To: T10 Technical Committee  
From: Rob Elliott, HP (elliott@hp.com)  
Date: 11 September 2004  
Subject: 03-240r5 SAS-1.1 Internal wide connector and cable

**Figure 1 — Internal wide connector plug picture (from Amphenol)**

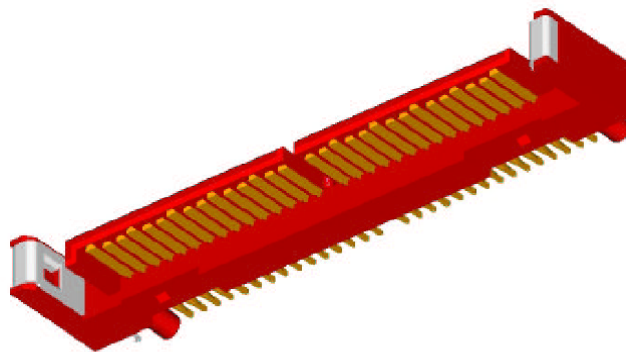
Editor's Note 1: The connector ended up with 6 sidebands in the middle rather than 4 as shown.

**[Figure 2 — Internal wide cabled environment - controller to backplane - symmetric cable](#)**

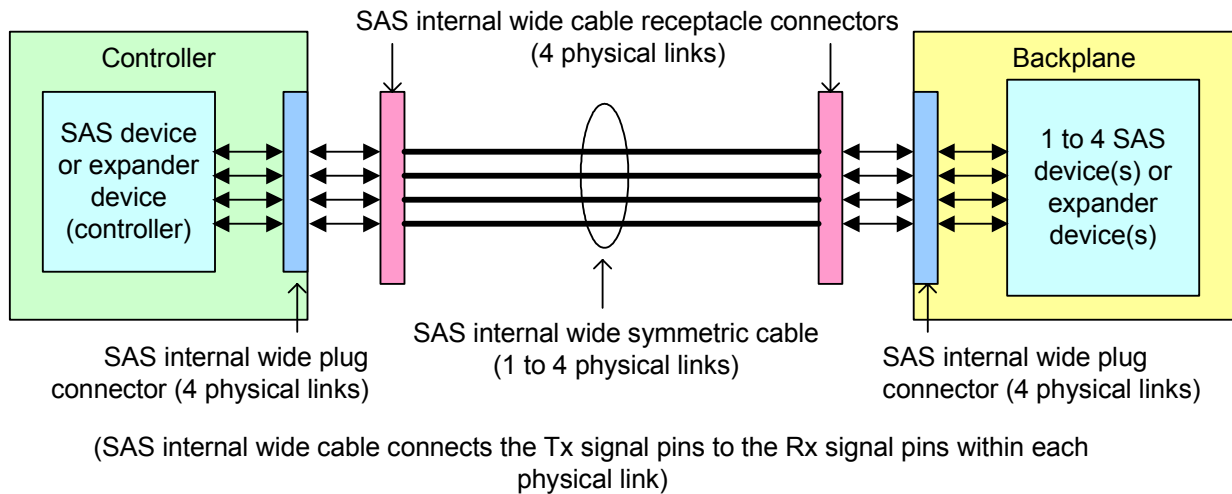
[Figure 2 shows a schematic representation of the cables and connectors defined in this standard for the internal wide cabled environment attaching a controller to a backplane using a symmetric cable.](#)

[The internal wide cable receptacle connectors have different pinouts for the controller end and the backplane end so one end's Tx signals are attached to the other end's Rx signals.](#)

**[Figure 3 — Internal wide cabled environment - controller to controller - symmetric cable](#)**

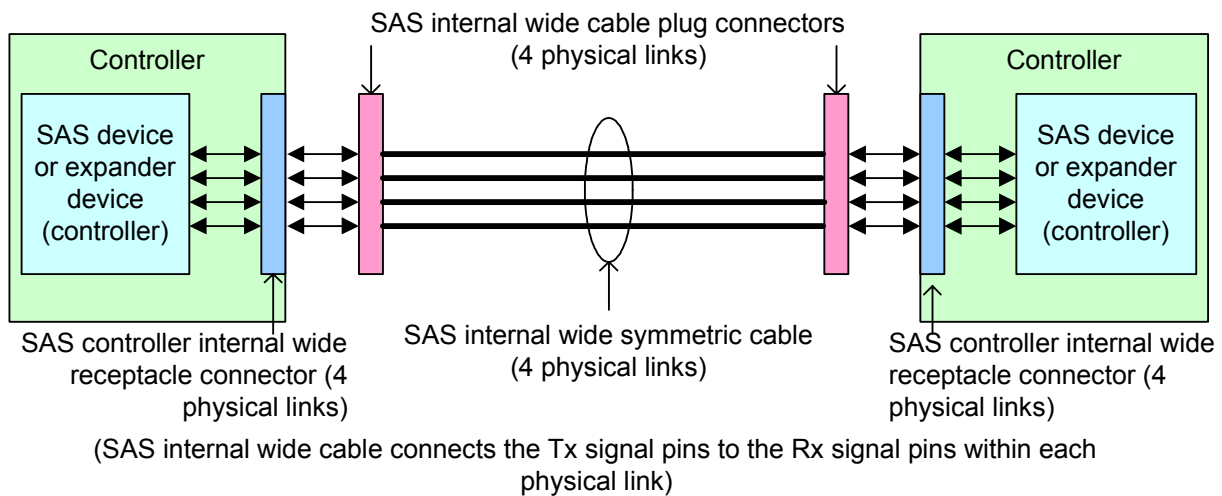
[Two controllers may also be attached together with a symmetric cable, provided all four physical links are used, since one end's physical link 0 is attached to the other end's physical link 3. Figure 3 shows the internal wide cabled environment attaching a controller to a controller using a symmetric cable.](#)

**[Figure 4 — Internal wide cabled environments with fanout cables](#)**

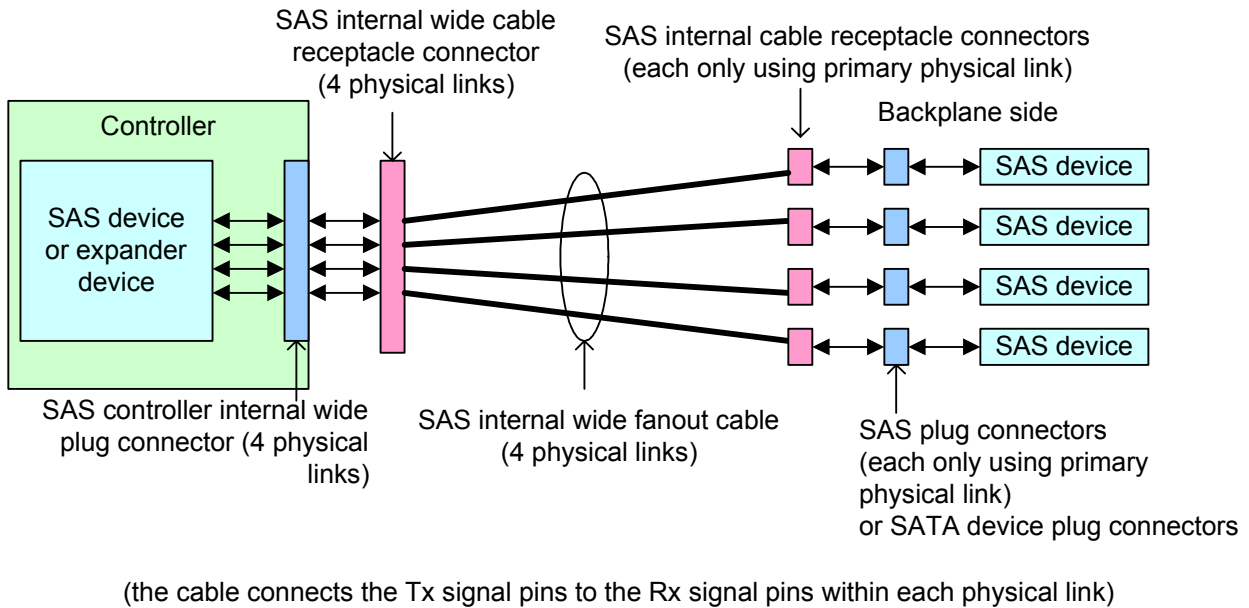
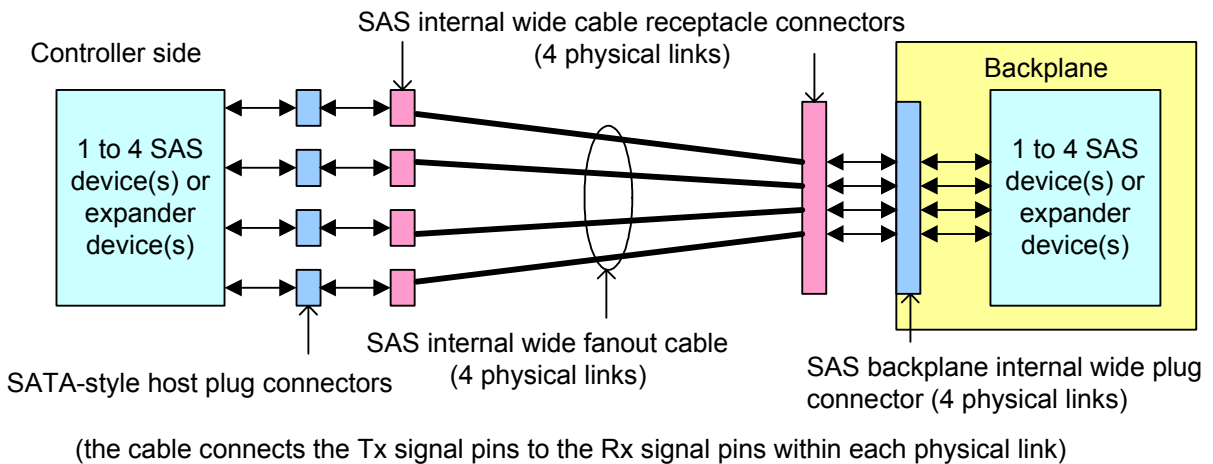
[Figure 4 shows a schematic representation of the cables and connectors defined in this standard for the internal wide cabled environments attaching controllers and backplanes using fanout cables.](#)

**Figure 5 — SAS internal wide cable attaching controller to backplane**

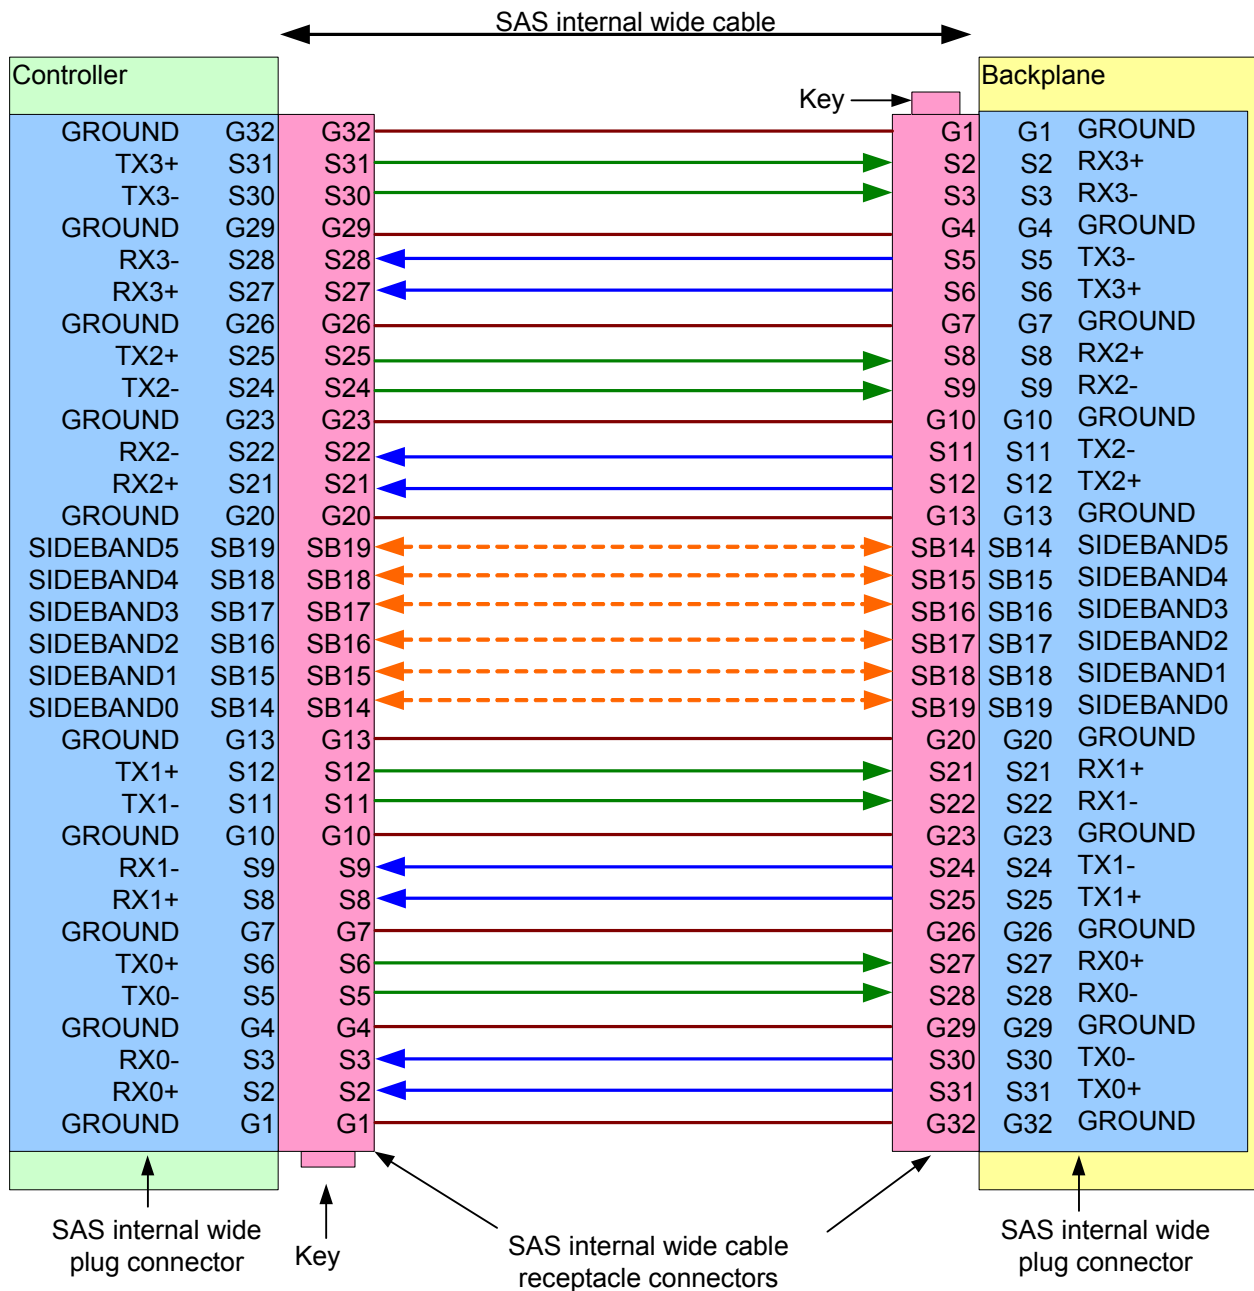
Figure 5 shows the SAS internal wide cable being used to attach a controller to a backplane.

NOTE 2 - For controller to backplane uses, up to four physical links may be used. SIDEBAND signals on the controller are attached to the corresponding SIDEBAND signals on the backplane (e.g., SIDEBAND0 of one controller is attached to SIDEBAND0 of the other controller).

**Figure 6 — SAS internal wide cable attaching controller to controller**

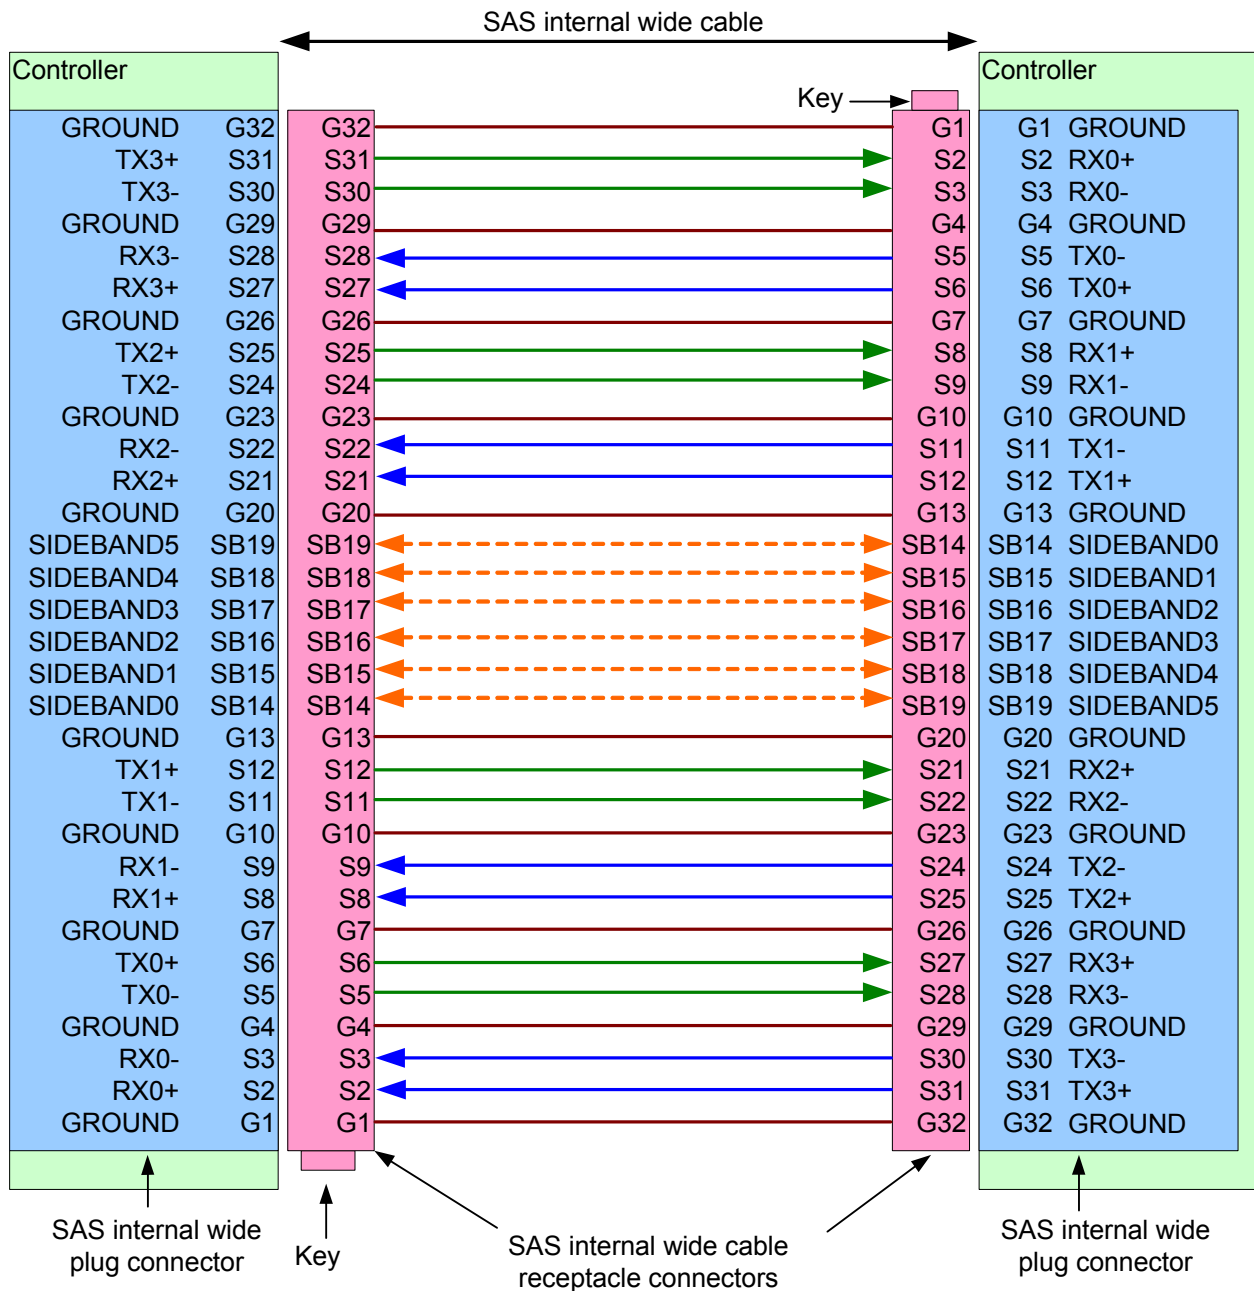
Figure 6 shows the SAS internal wide cable attaching two controllers.

NOTE 3 - For controller to controller uses, all four physical links should be used, because one controller's physical link 0 is attached the other controller's physical link 3. If both controllers used only physical link 0, they would not communicate.

NOTE 4 - For controller to controller uses, SIDE BAND signals on one controller are not attached to their corresponding SIDE BAND signals on the other controller (e.g. SIDE BAND0 of one controller is attached to SIDE BAND5 of the other controller).

Figure 7 — SAS internal wide controller-based fanout cable

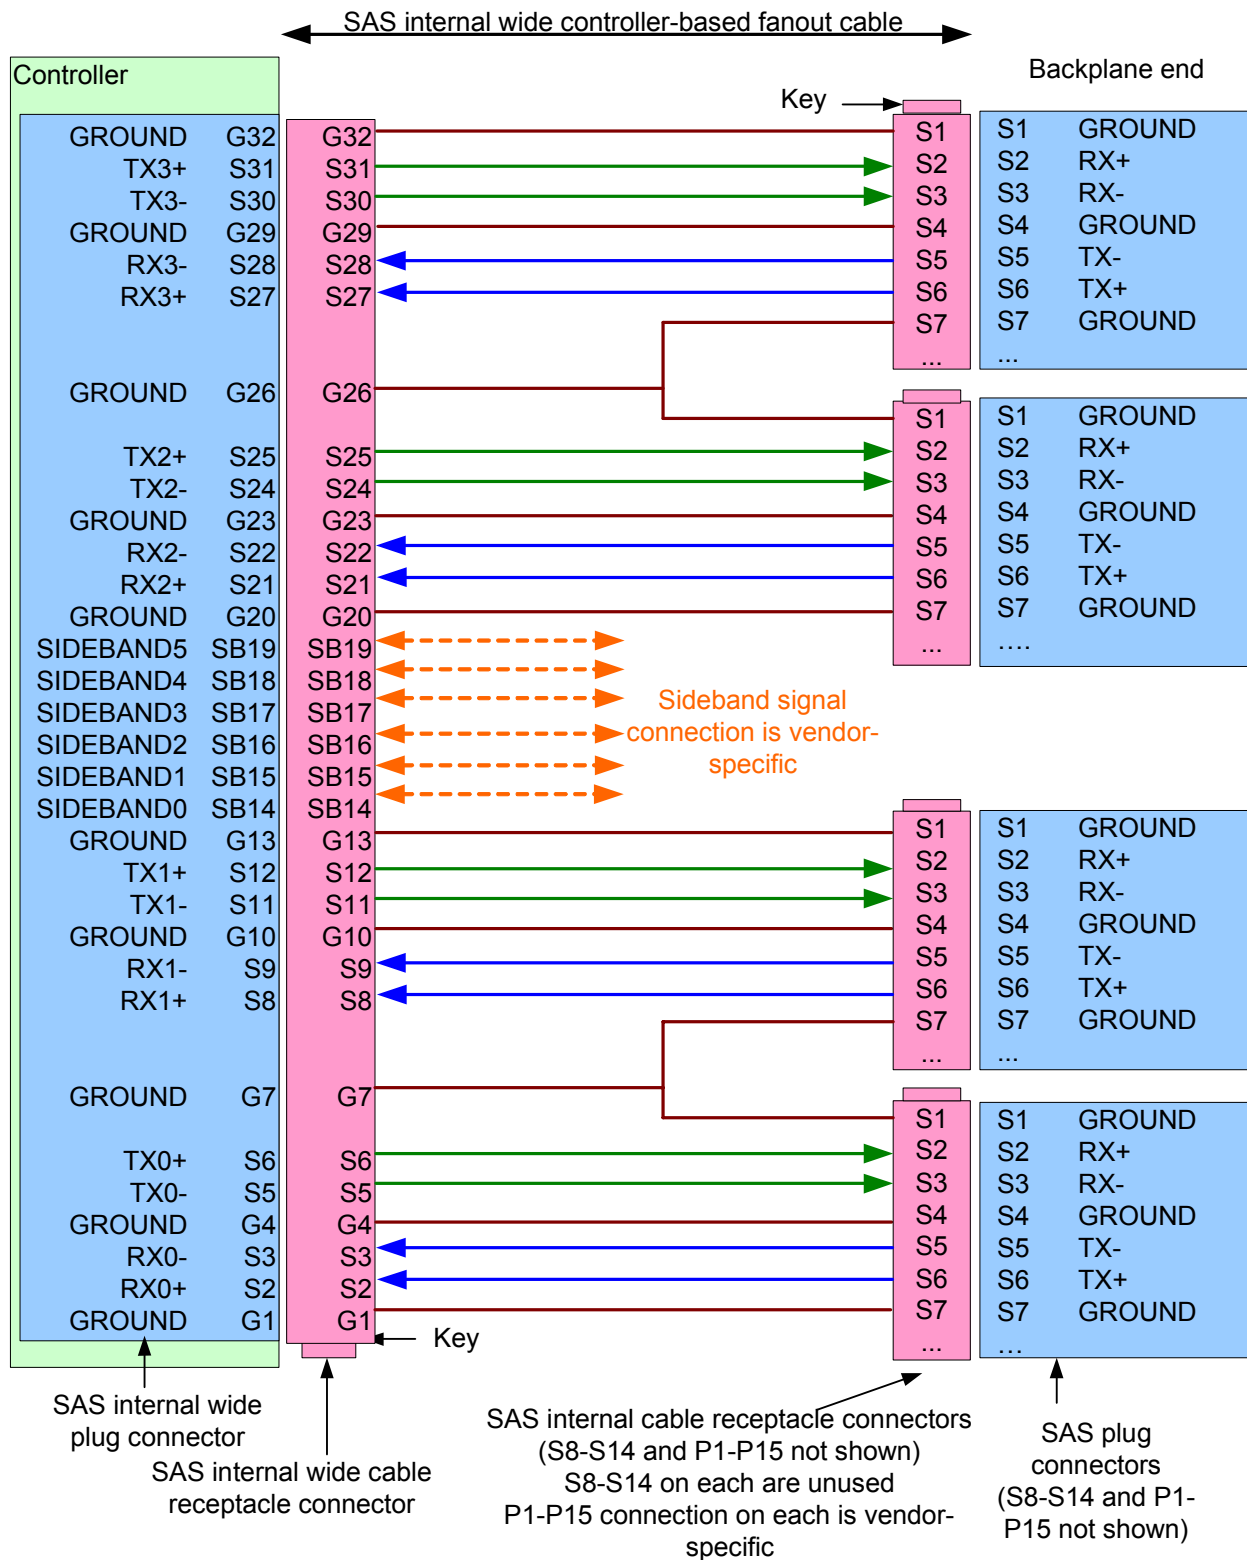
Figure 7 shows the SAS internal wide controller-based fanout cable.

Figure 8 — SAS internal wide backplane-based fanout cable

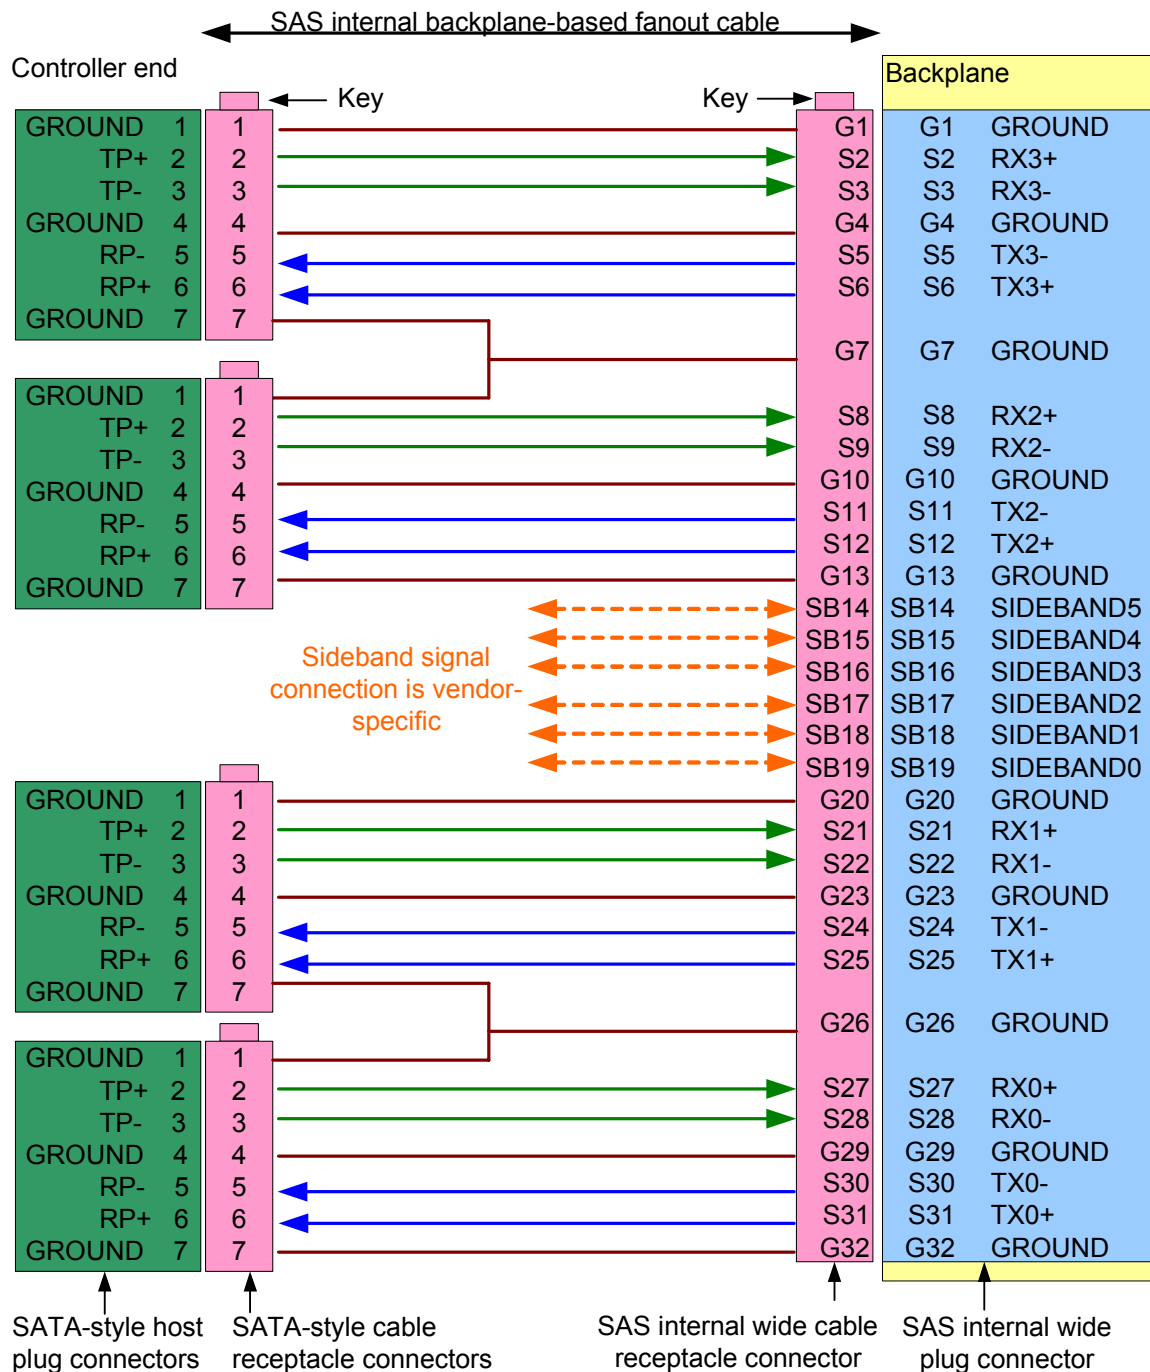
Figure 8 shows the SAS internal wide backplane-based fanout cable.
